## **SERVICE LETTER August 22 02**

This Service Letter defines nose gear re-enforcement.

The affected models are aircraft CH 2000 serial numbers 20-002 and up.

**Required Parts – Firewall:**

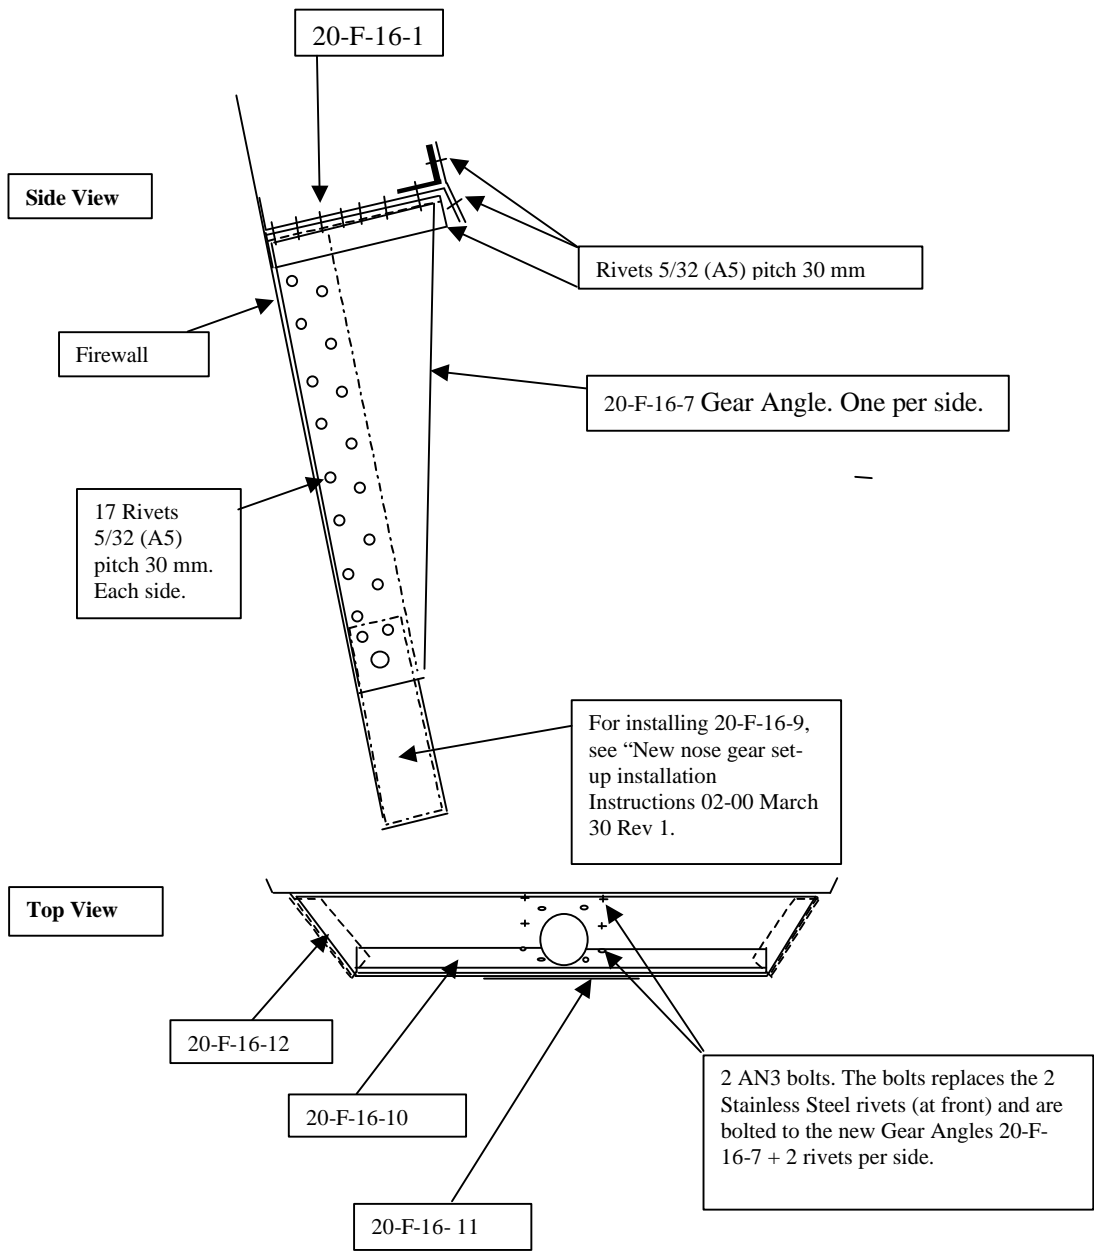
Assemble parts as per following drawing. Remove engine from firewall, remove gear bungee and bungee pin 20-F-16-5, and remove angles 20-F-16-7. Make sure that Center Channel Doubler 20-F-16-9 is already installed as per "New nose gear set-up installation Instructions 02-00 March 30 Rev 1.

20-F-16-7/4	Gear Angle, t=.040 aluminum 6061-T6	Qty 1L+1R
20-F-16-10/0	Upper Angle, t=.063 aluminum 6061-T6, L=435mm L angle	Qty 1
20-F-16-11/0	Forward Gusset, t=.063 aluminum 6061-T6, L=200mm	Qty 1
20-F-16-12/0	Side Brace, t=.040 aluminum 6061-T6, L=170mm L angle	Qty 1
A5	5/32 aluminum rivet	Qty 68
AN3-6A	3/16 bolt with nut and washer	Qty 2

## Tail Skid Area

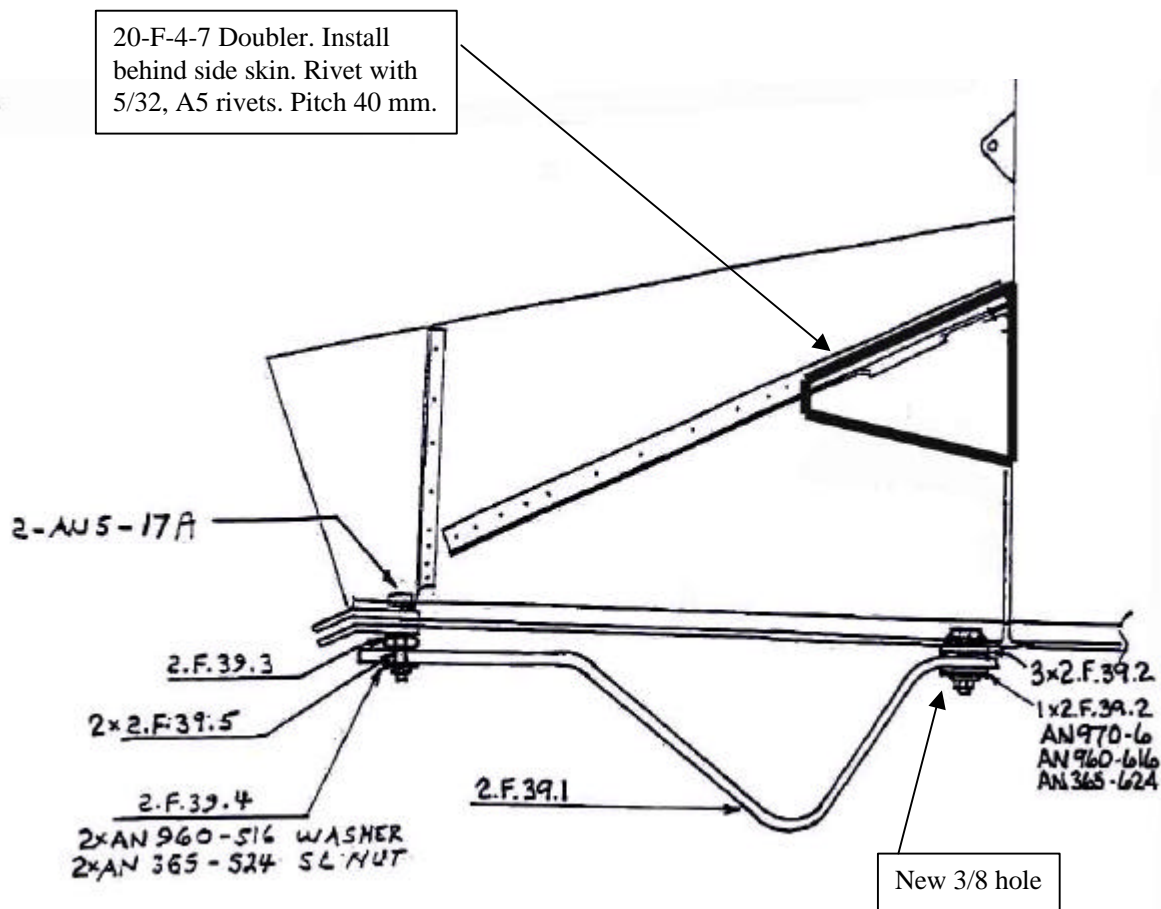
Remove tailskid 20-F-39-1. Drill 3/8 hole in tailskid, 35 mm from the end, that has no hole. Turn tailskid around and reinstall with above hardware.

Install Lower rear side skin Doubler. Drill out rivets where Doubler will go. Slide Doubler between side skin and horizontal tail frame, drill through existing holes through Doubler. Add a rivet line with similar rivet pitch, about 40 mm. apart. Rivet with 5/32, A5 rivets.
